Groundwater Transfer Review Summary Form

Transfer/PA # T- 14832

Ground Water Review Form:

Application: T-14832

Cross Section

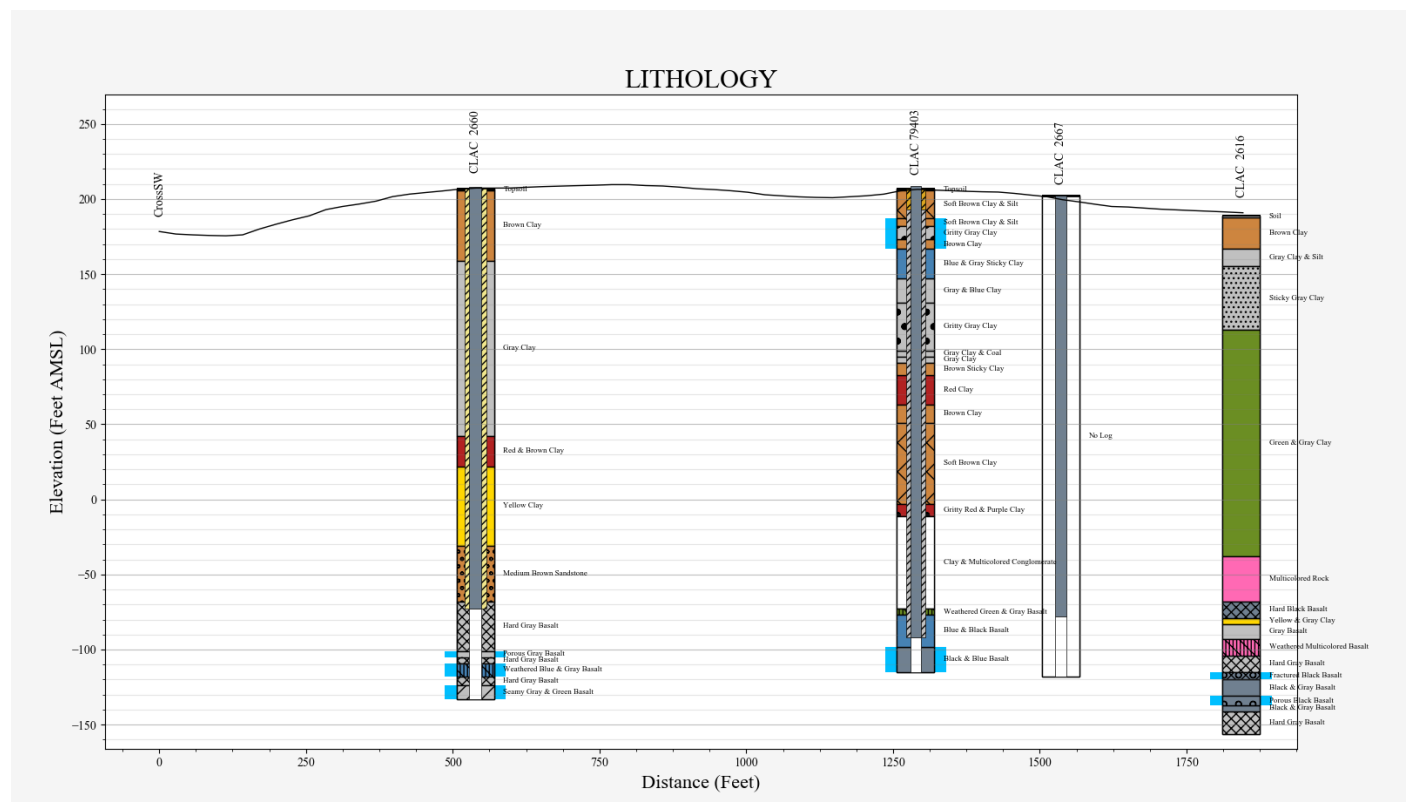
2. Will the proposed POA develop the same aquifer (source) as the existing authorized POA?
Yes No Comments: Although the from-POA (CLAC 2667) does not have lithology recorded, from-POA (CLAC 2667) does not have lithology recorded, given the depth and location it likely develops a water-bearing zone, WBZ, in the Columbia River Basalt Group, CRBG, probably the youngest flow in the area which is the Basalt of Sand Hollow (Martin et al., 2013; Reidel et al., 2013; Conlon et al., 2005; Gannett and Caldwell, 1998; Woodward et al., 1998; nearby wells, see attached Cross Section). The to-POA (CLAC 79403) develops the same aquifer.
